CITY OF ALBUQUERQUE

PLANNING DEPARTMENT – Development Review Services

RE: Bishops Compound (File: G12D032)
Drainage and Grading Plan, Engineer's Stamp Date 10-3-2016
Supplemental Calcs, Engineer's Stamp Date 9-21-2016

Bishops Compound
DRC #727183

GRADING & DRAINAGE PLAN

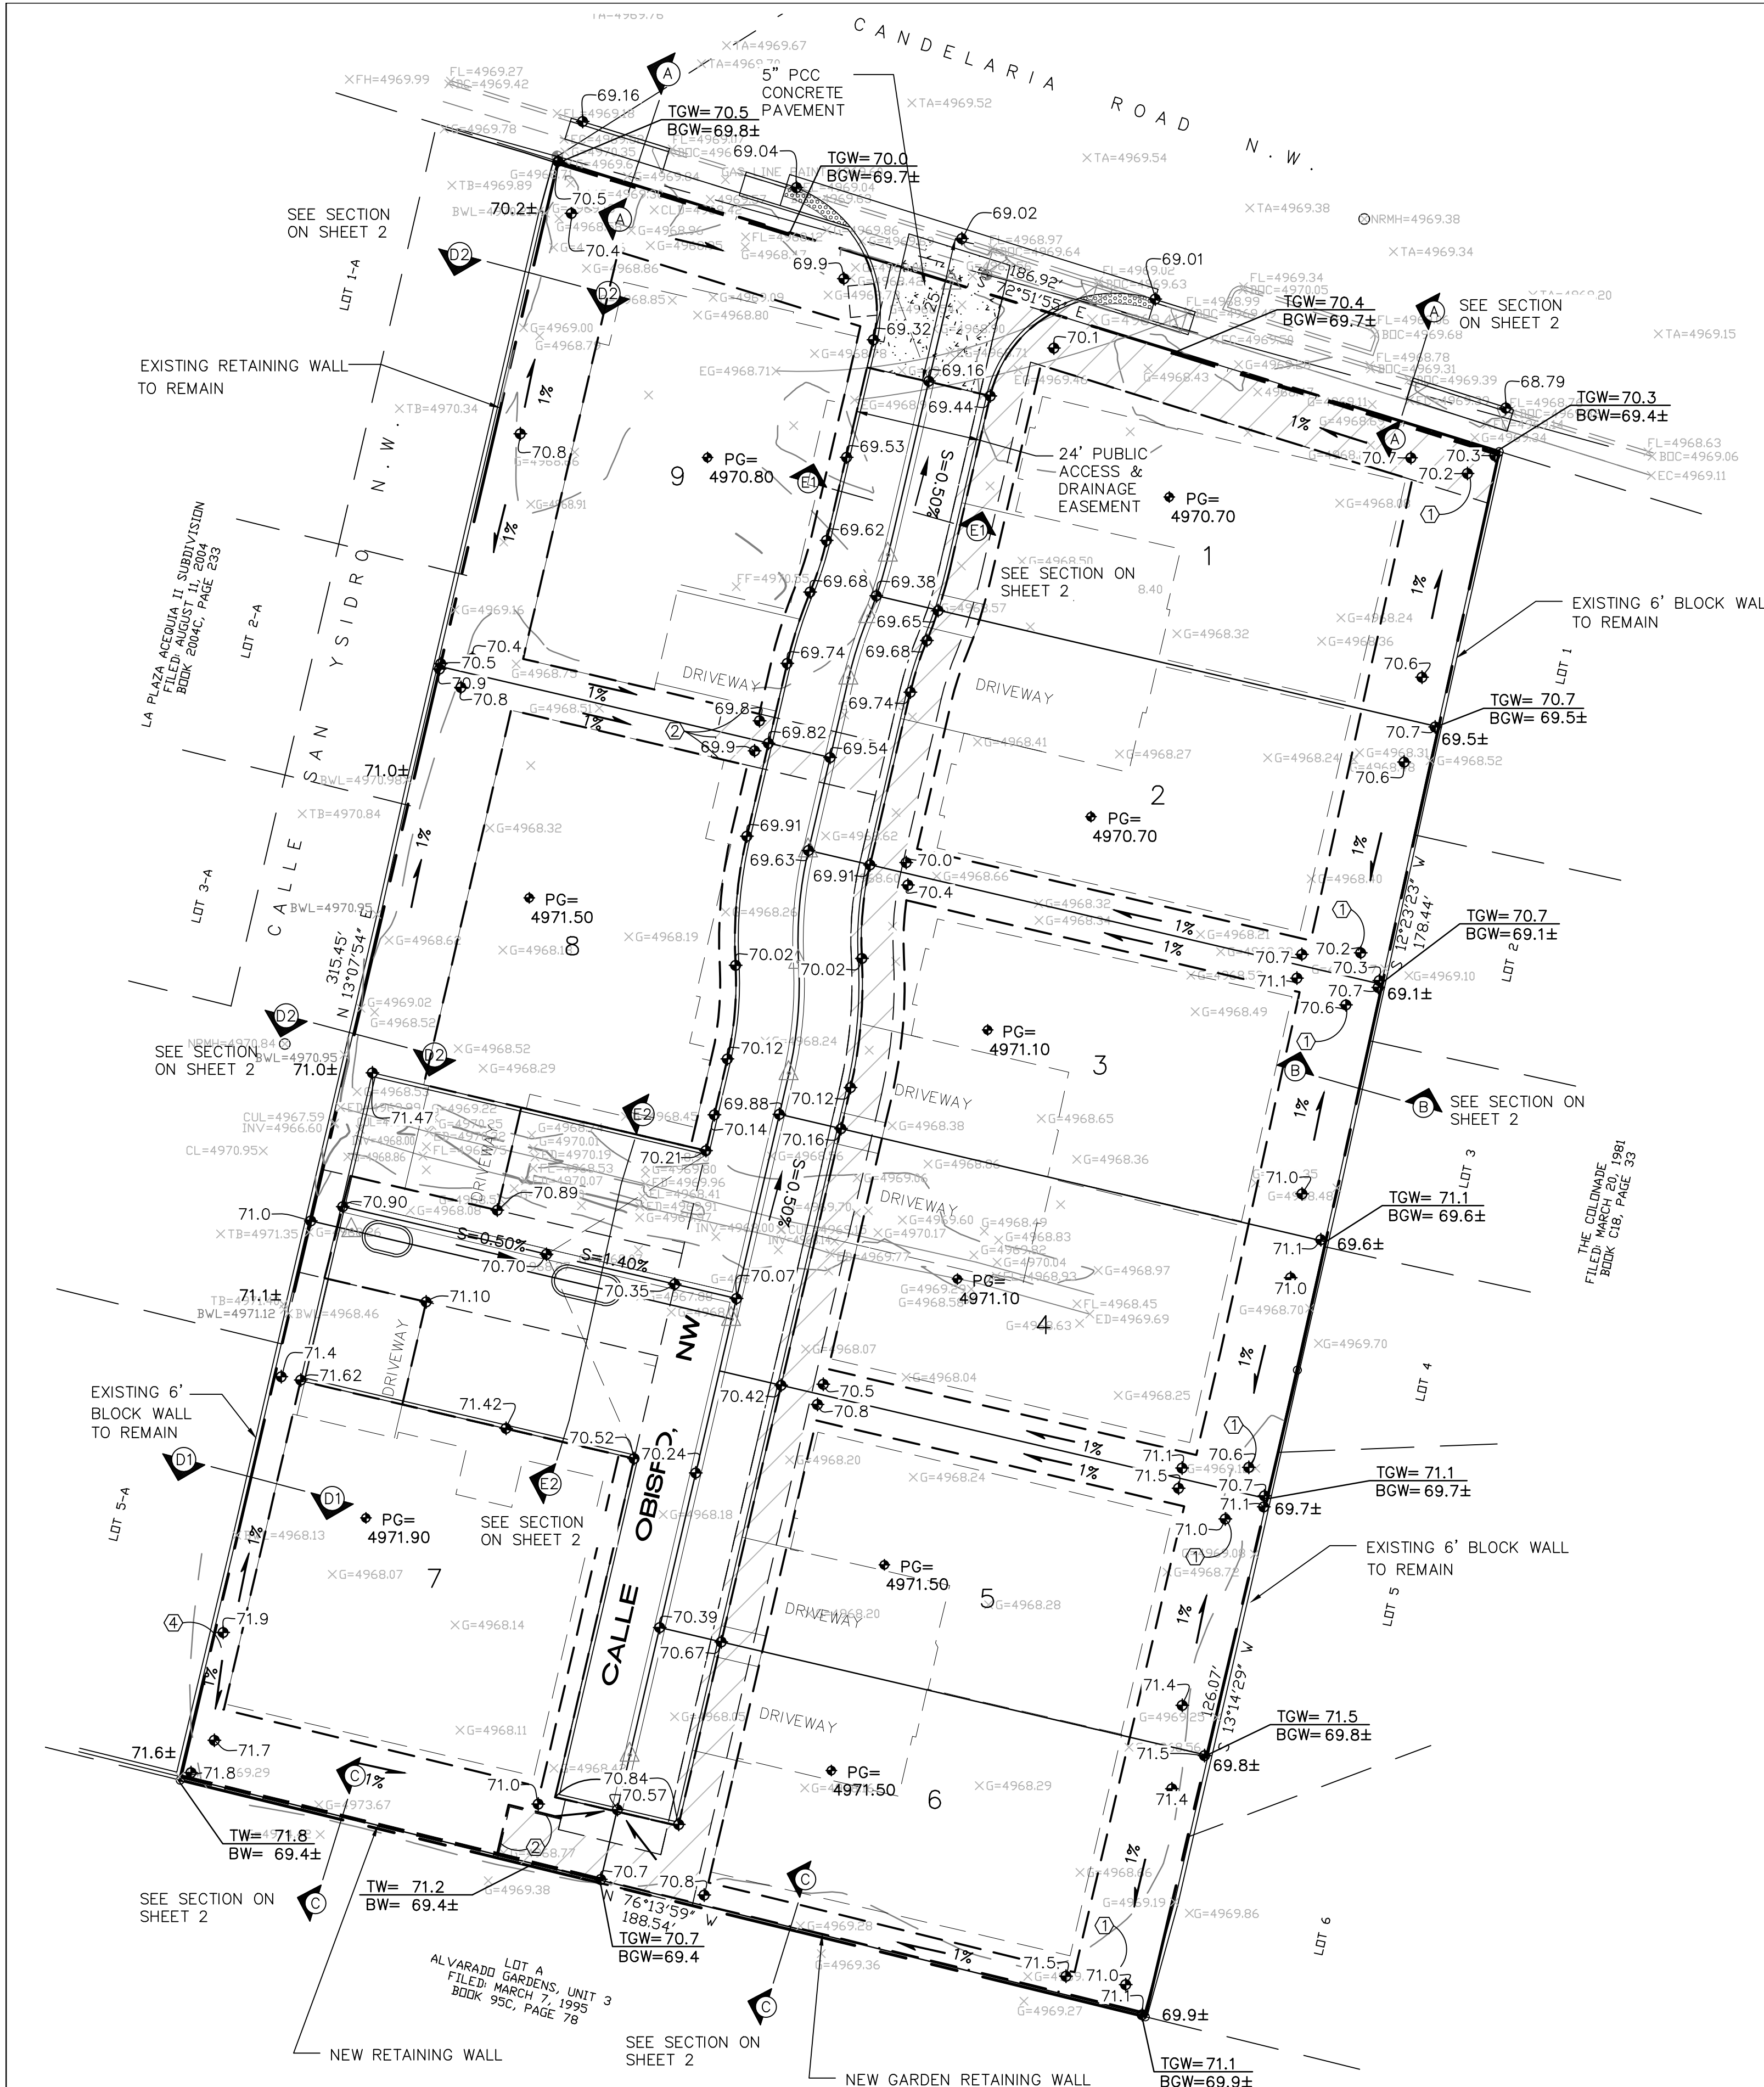
Based upon the information provided in your submittal received 10-4-2016, the above referenced plan is approved for ESC Permit (Grading Permit) with the condition that an ESC Plan be submitted and approved.

Prior to Pad Certification and/or Release of Financial Guarantee approval, Engineer Certification per the DPM checklist will be required.
